SUBJECT: Permit Modification Request for Section 404 Individual Permit and Section 401 Individual Water Quality Certification for the new location facility from SR 2011 to the Haw River at US 220, Greensboro, Guilford County; Division 7; TIP No. R-2413A/B

The North Carolina Department of Transportation (NCDOT) awarded the design-build team this project on April 8, 2014 to construct projects R-2413A, R-2413B, and I-5110. Sections R-2413A and B were authorized by the USACE and NCDWR as referenced above. We are requesting a modification in the permits for a new impact area: Permit Site 24 in Section R-2413A.

Permit Site 24. Impacts were avoided in the original design at this stream crossing as the plans called for a gravity wall to carry the extra lane. However, further geotechnical analysis determined that due to stability issues, neither the gravity wall nor other options (MSE, pile panel, etc.) were viable as they would impact either existing traffic on NC 68 or the pipes under NC 68. Therefore, the only option is to extend the pipes under NC 68, which will result in impacts of 15 LF of permanent fill, 31 LF of bank stabilization, and 10 LF of temporary fill in surface waters. Pl

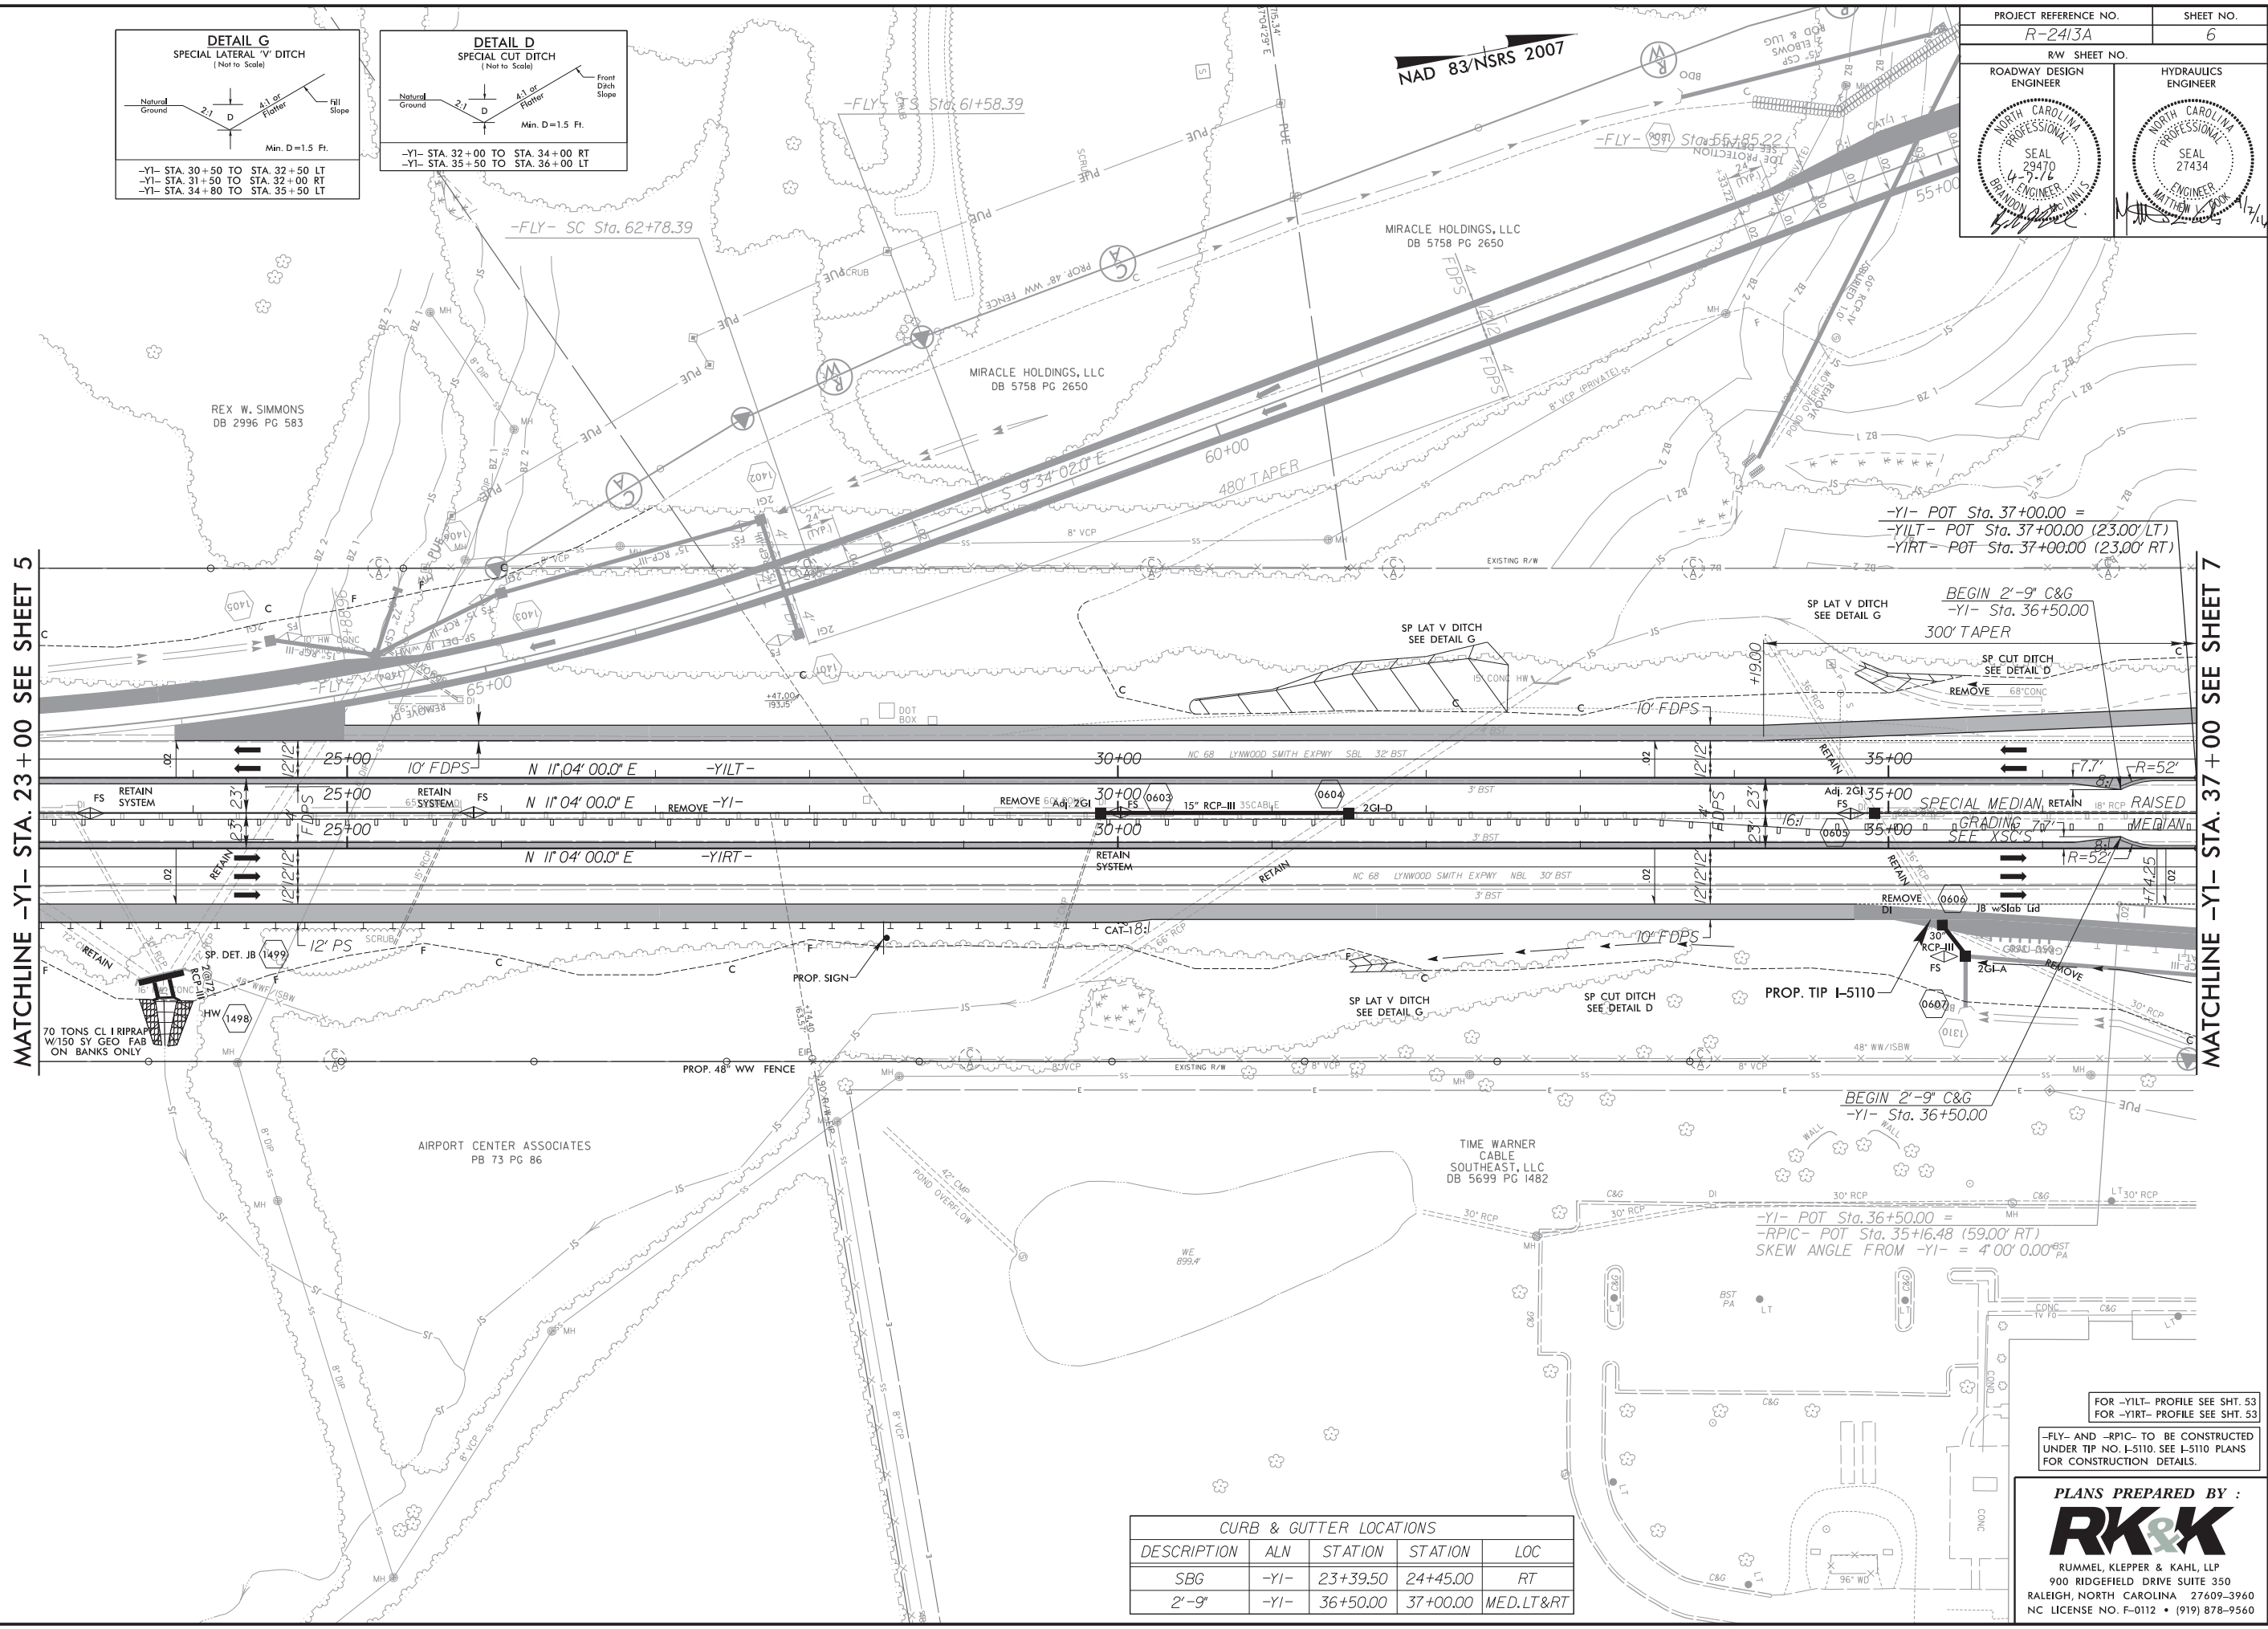
CONST. REVISION - 05/04/2015 - REVISED SLOPE STAKES AND DITCH LOCATION FROM -YI- STA. 23+00.00 TO 25+50.00 LT.
 CONST. REVISION - 05/04/2015 - REVISED PROPERTY OWNER NAME TO TIME WARNER CABLE SOUTHEAST, LLC.
 CONST. REVISION - 07/01/2015 - ADDED GUARDRAIL FOR SIGN LOCATED AT -RPIC- STA. 34+50 LT.
 CONST. REVISION - 09/01/2015 - ADDED GUIDERAIL PROTECTION IN THE MEDIAN FOR SIGN LOCATED AT -YI- STA. 37+00.
 CONST. REVISION - 04/06/2016 - REMOVED RETAINING WALL AND ADDED PIPE EXTENSION AT -YI- STA. 23+40 RT.
